January 15, 1997

R.E.: Revised Drainage Plan For Virginia Street Apartments (K19-D114) Revision dated 1/3/97

VIRGINIA STREET APARTMENTS
GRADING & DRAINAGE PLAN

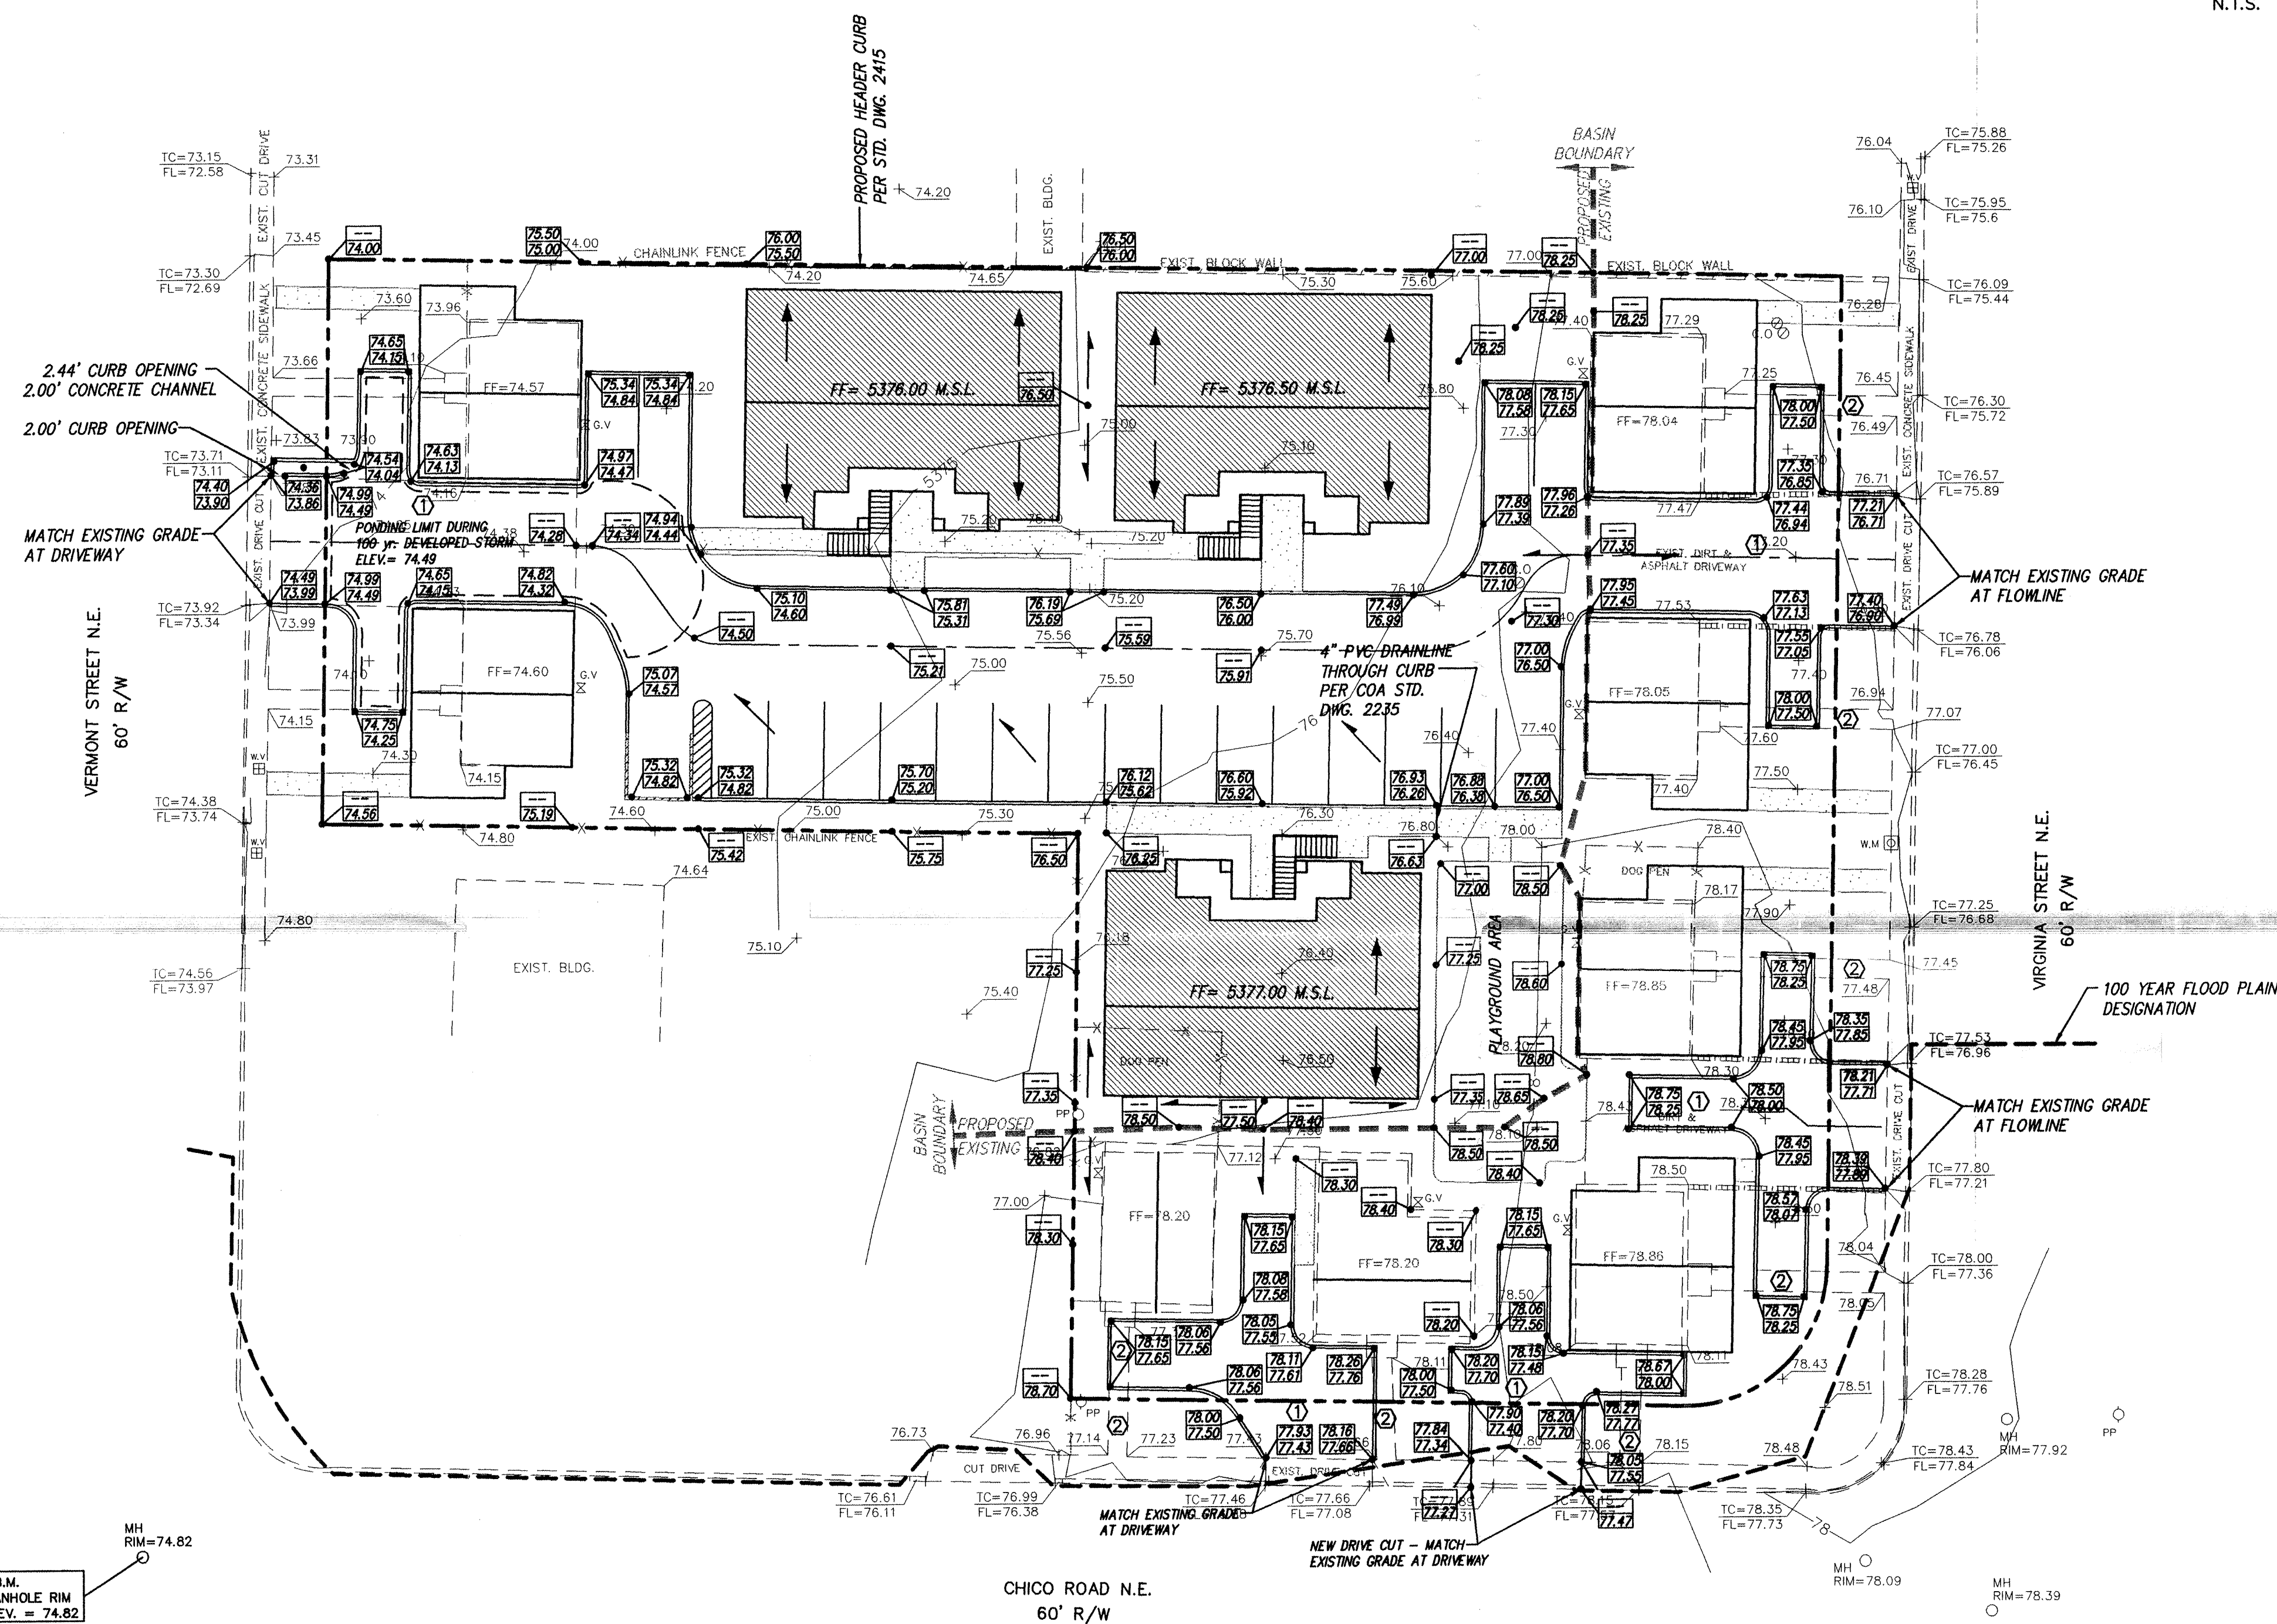
Based on the information provided on your January 3, 1997 resubmittal, the above referenced site is approved for Grading/ Paving and Building Permit.

Please attach a copy of this approved plan to the construction sets prior to sign off by Hydrology.

Also, prior to Certificate of Occupancy release, Engineer Certification per the D.P.M. guidelines will be required.
